MEMORANDUM

Re: Planning Commission Recommendation concerning
Ordinances No. 226-2025 and Ordinances No. 227-2025

Planning Commission Comments on Ordinance No. 226-2025, Exhibits A & B

Severance B-1 Design Comparison

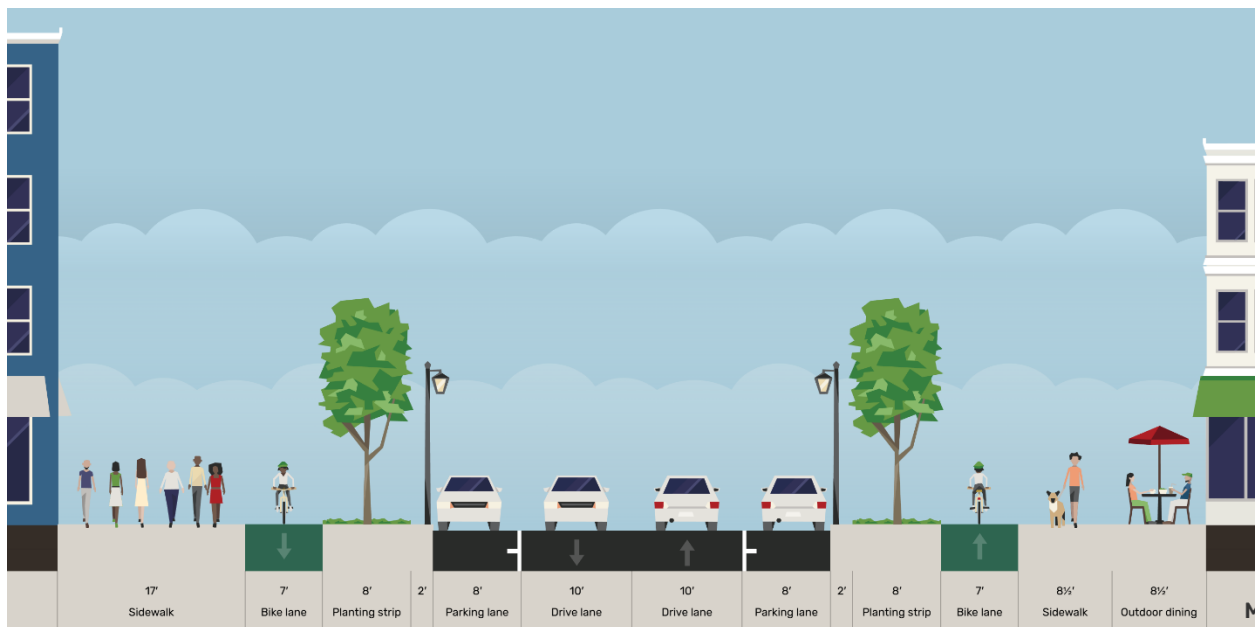
<p>Page 29</p> <p>Chapter 1149.43 A</p> <p>Street A-1</p>	<ul style="list-style-type: none"> • There should be a dimension on the bike lane (BL) in the graphic. The standards call out a dimension for "PB." The graphic and the dimensions should be consistent.
<p>Pages 37-49</p> <p>1149.43A -1149.43M</p> <p>Street</p>	<ul style="list-style-type: none"> • Recommend Drive Lane (DL) have maximum width of 10 feet. (diagram is last 2 pages of Attachment A)
<p>Page 51</p> <p>Chapter 1149.45 B</p> <p>Pedestrian Clearway</p> <p>Design Standards</p>	<ul style="list-style-type: none"> • Remove Note (3) stating "Pavement materials shall be approved by the Architectural Board of Review"
<p>Page 66</p> <p>Chapter 1149.48 I Edging</p> <p>Element Design</p> <p>Standards</p>	<ul style="list-style-type: none"> • Correct numbering: Landscape Edge should be EE-5
<p>Global within Chapter</p> <p>1149</p>	<ul style="list-style-type: none"> • Capitalize Zoning Administrator
